N1913A-04A

S E R V I C E N O T E

N1913A EPM Series Single-Channel Power Meter

Lack of Front Sensor Input for N1913A–Option 109

Figure 1

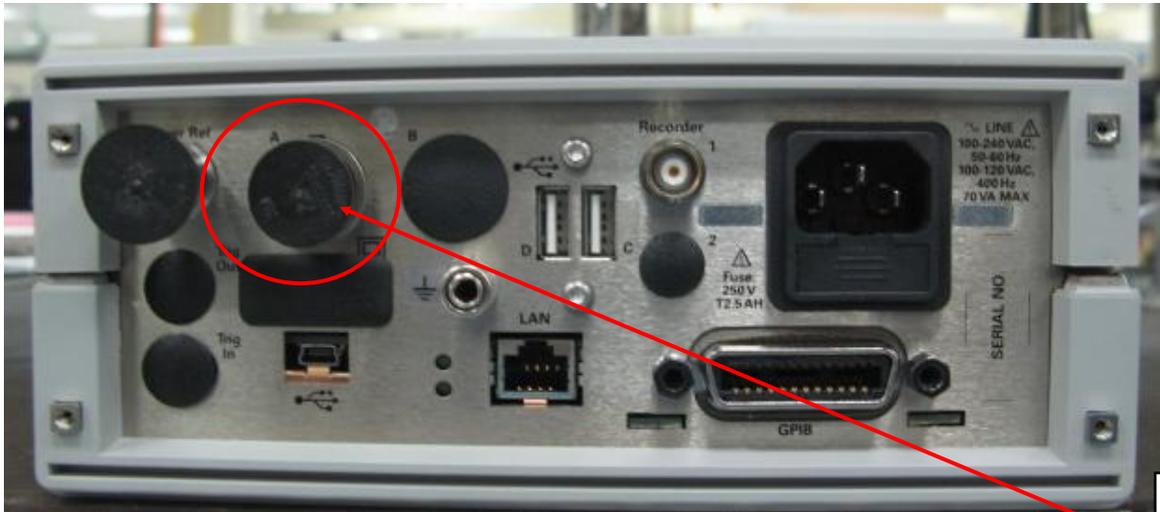
1. The N1913A option 109 should come with front and rear sensor inputs as stated in the product's User Guide.
2. However, the documented serial numbers only had the rear sensor input.
3. This service note is to notify the availability of the modification to install the missing front sensor input.
4. Meanwhile, all the new units of N1913A option 109 will come with sensor inputs in front and rear panel, rear panel reference calibrator connector and 2 rear USB ports.

1. Customer can contact Agilent's Customer Contact Center (CCC) for returning the unit to Agilent's Service Center for a factory rework.
2. CCC will arrange with Agilent's Customer Service Representative (CSR) for sending the prepaid shipping label to customer for a no-charge return to the Agilent Service Center
3. Figure 1 and figure 2 show the physical condition of the N1913A option 109 after install of the front sensor input. The sensor inputs are installed at front and rear panel of N1913A.

Sensor inputs are available in rear and front panel now
